Proposed Amendments to the Small Scale Residential (RS) Zone

Interior Side Setbacks

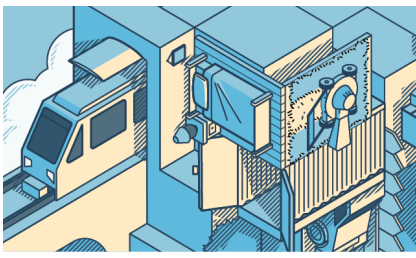
Administration proposes to increase the minimum interior side setback from 1.5 m to 1.9 m for row housing and multi-unit housing where an entrance is located on the side of a building.

Intended outcome: Improve functionality of side yards by allowing for a 0.15 m drainage swale, 0.9 m pathway and 0.76 m egress window well or portion of a stairway.
